Response to Review of Hillslope hydrology under glass: confronting fundamental questions of soil–water–biota co-evolution

T. Meixner (Referee)

Received and published: 24 July 2009

[Grayson and Blöschl, 2001]

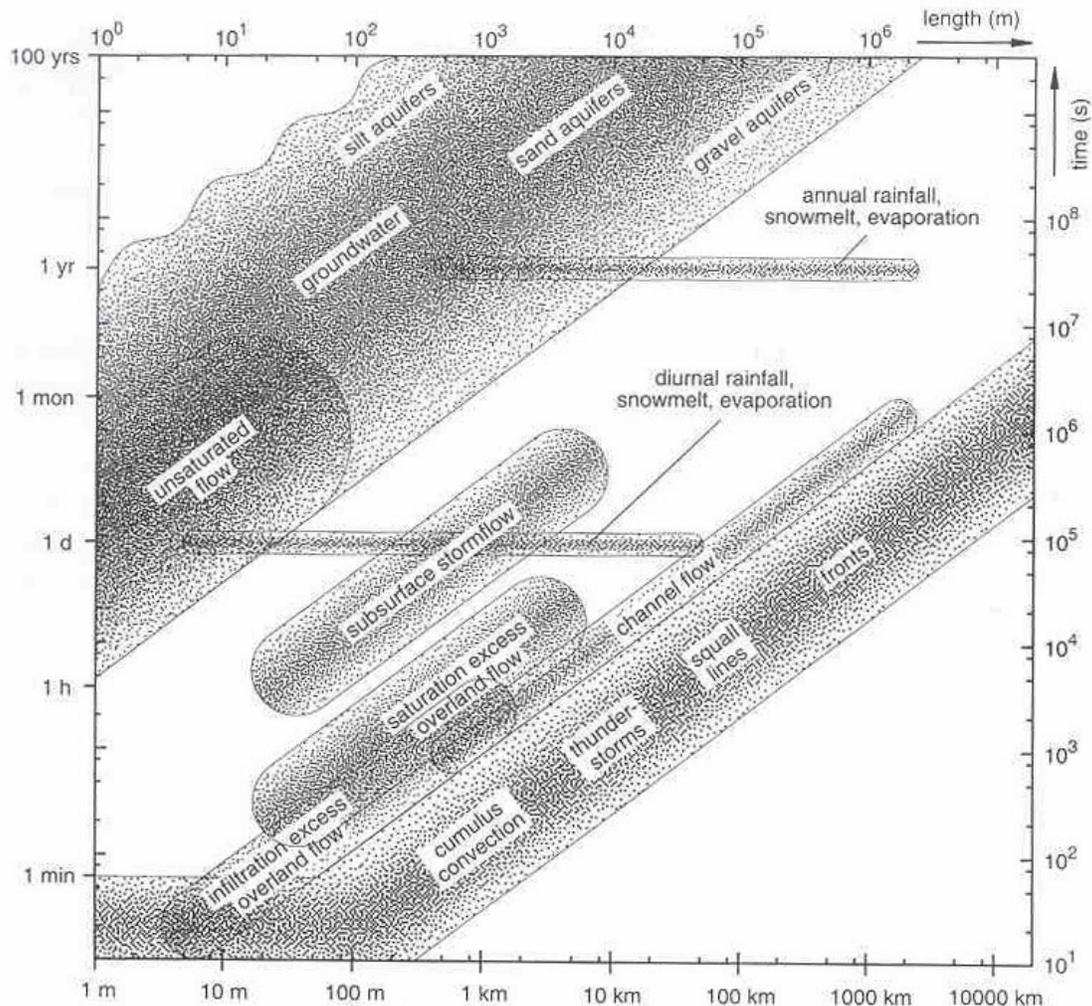
A way to possibly help the community visualize the limitation imposed by the various design criteria is to place the design criteria within the context of a commonly used descriptive figure in hydrology.

The Red box seems to me the domain that the hillslope will operate within. Other design factors may further constrain or expand this region. A comment from the authors about this would be appreciated.

This is a very good point, and while we cannot discuss in detail (due to space limitations in the paper) the processes that the proposed hillslope design may facilitate or exclude we added a paragraph to the discussion, section 4.1, touching on this issue. We argue that the proposed hillslope design is able to answer questions that center around how subsurface hydrological, geochemical and biological processes interact to create heterogeneity and temporal/spatial structure.
